IEEE P802.3da Comment #123 on Mode Conversion

David D. Brandt, Rockwell Automation

147.8.3 Mode conversion loss

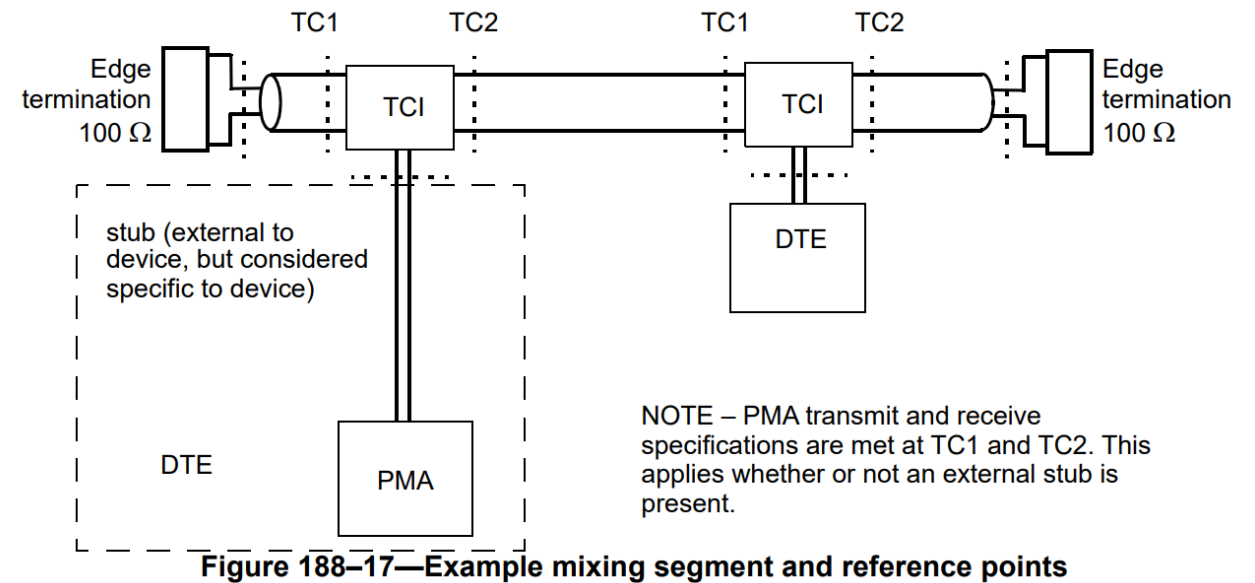
- Clause 147 specifies “where” the specification applies
 - **Impractically large** number of measurements

The mixing segment shall meet the mode conversion loss characteristics specified for link segments in 147.7.3 **between any two MDI attachment points.**
